Docket Item # 10
BAR CASE # 2007-0209

BAR Meeting
October 17, 2007

ISSUE: Demolition/Encapsulation
APPLICANT: Ian McGrath by Ray Lewis
LOCATION: 1315 King Street
ZONE: KR/King Retail

Figure 1: Existing façade

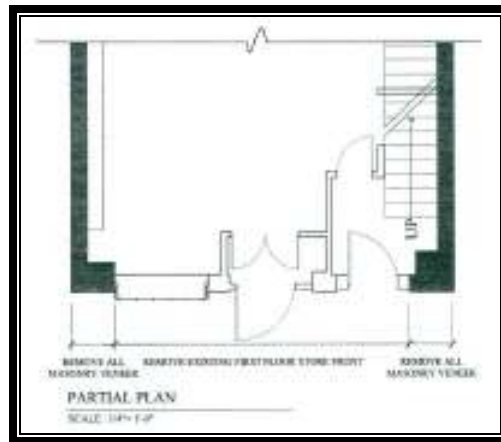
The applicant is requesting approval of a Permit to Demolish/Encapsulate in order to make alterations to the façade of 1315 King Street. The storefront, consisting of a multipaned display window, two entry doors, portion of the brick veneer exterior, and a wood shingled shed roof with overhang will be removed. The area to be demolished is approximately 16' wide and 8' tall, or approximately 128 square feet. All the brick veneer is also proposed to be removed.

From visual inspection, the alterations of the storefront to 1313-1315 King Street, including the brick veneer, the wood shingles shed roof and overhang, and the multipaned window, appear to have occurred in the 1970's, in order to give the building a modified "Colonial" appearance. In the opinion of Staff, because the proposed demolition impacts alterations that occurred in the later part of the 20th century structure, none of the criteria for demolition and encapsulation are met in this instance. Therefore, staff supports the application.

Staff recommends approval as submitted.
